**PLANNING AND ZONING COMMISSION MEETING**

Tuesday, November 9, 2021, at 4:30 PM  
191 5<sup>th</sup> Street West, Ketchum, Idaho

5. ACTION - Recommendation to approve the 380 N 1st Ave Mixed-Use Building Design Review (Application File No. P21-085).

**STAFF REPORT  
KETCHUM PLANNING AND ZONING COMMISSION  
MEETING OF NOVEMBER 9, 2021**

**S4.0**

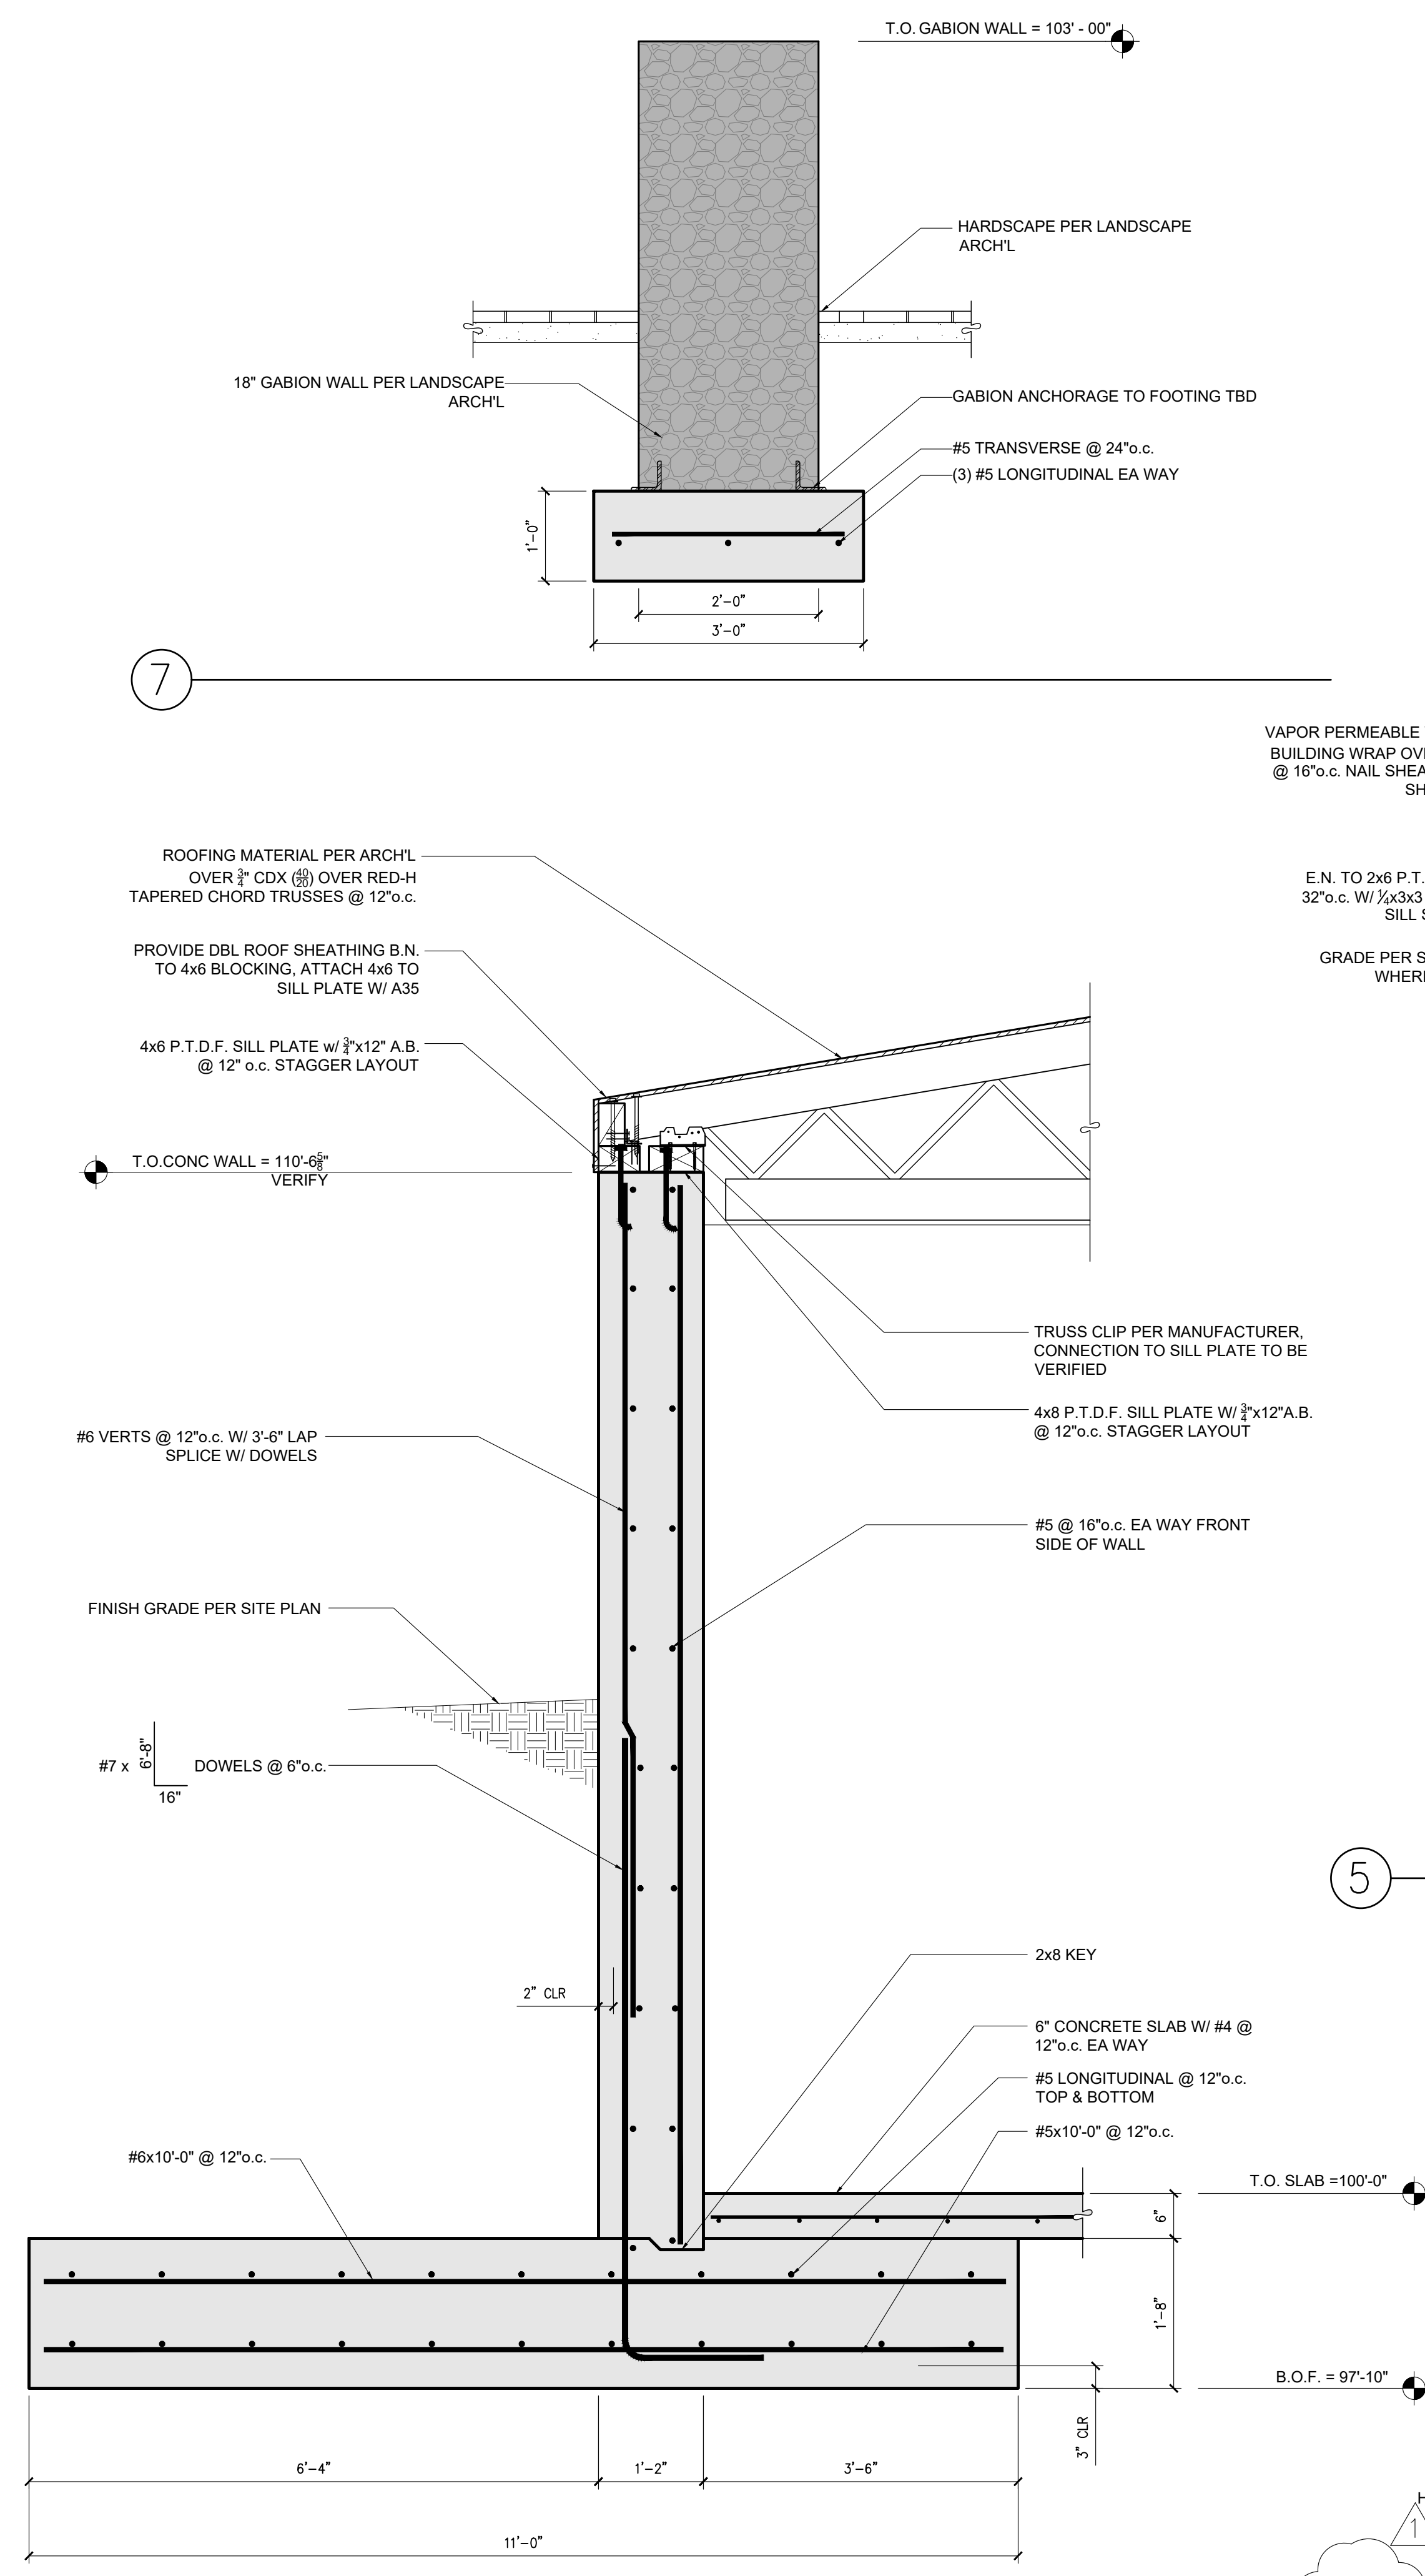
The structural details on Sheet S4.1 show that the concrete wall is 9 feet-2 inches in height from the bottom of the footing to the top of the wall. As noted in the applicant's letter (Exhibit A), the wall has been engineered to withstand the avalanche forces that may impact the property. The foundation plan on Sheet S2.0 (See Figure 2) shows that the avalanche wall and building foundation footings are connected.
